**STAFF REPORT**  
**COMMUNITY DEVELOPMENT DEPARTMENT**

SUBJECT: AZ, PP - H-2021-0083  
Friendship Subdivision

B. Preliminary Plat (date: 12/17/2021 1/31/2022)

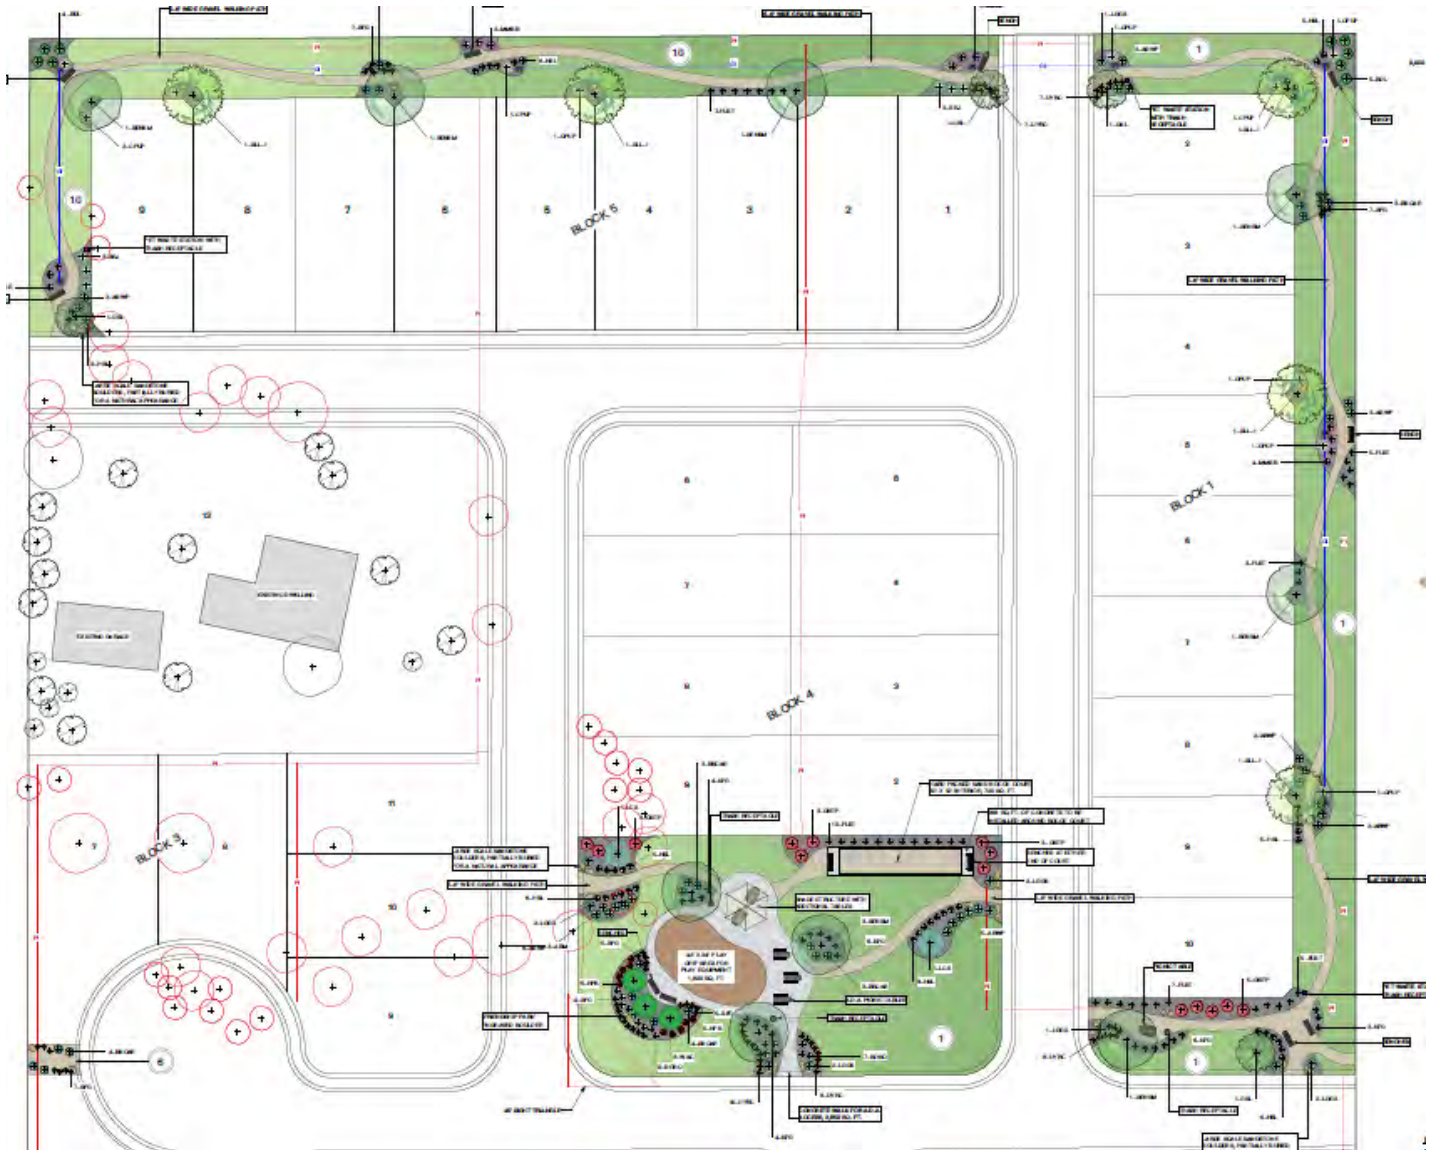
*As mentioned, the Birkdale Estates Subdivision is to the west (R-2), the Hightower Subdivision is to the east (R-8) and the Saguaro Canyon Subdivision (R-4) is to south, with an existing church zoned RUT to the north. The lots at the southern perimeter of the property are proposed at sizes between 5,000 – 7,000 sq. ft. and widths of between 50-70 ft. This is denser than the adjacent lots of approximately 10,000 sq. ft. and 90' feet in width in the Saguaro Canyon Subdivision to the south, and this would result in several of the existing properties abutting more than one lot (and one residence) along the rear property lines. **Staff recommends one of the lots shown as Lots 1-***

***4 of Block 2 be eliminated and the remaining 3 lots be sized and oriented to be consistent with Lots 1-3, Block 35 of the Saguaro Canyon Subdivision No 3 to the south.***

*The 5,200 sq. ft. +/- lots along the eastern perimeter are very comparable in size to the lots in the Hightower Subdivision to the east, although staff believes the side lot lines could align better with the adjacent properties for more cohesive fence lines and easier differentiation of property ownership. As a condition of approval, staff recommends Lots 1-10, Block 1 along the eastern perimeter be configured so their property lines align with Lots 4-11, Block 10 in the Hightower Subdivision to the east.*

There is one existing single-family residence which will be retained on Lot 9 of Block 3. As a condition of annexation, this house should be required to connect to City water and sewer service and obtain a new address since the access to N. Elk Ranch Ln. will be terminated.

- ~~b. One of the lots shown as Lots 1-4 of Block 2 shall be eliminated and the remaining 3 lots be sized and oriented to be consistent with Lots 1-3, Block 35 of the Saguaro Canyon Subdivision No 3 to the south.~~

- ~~c. Lots 1-10, Block 1 along the eastern perimeter shall be configured so the property lines align with Lots 4-11, Block 10 in the Hightower Subdivision to the east.~~
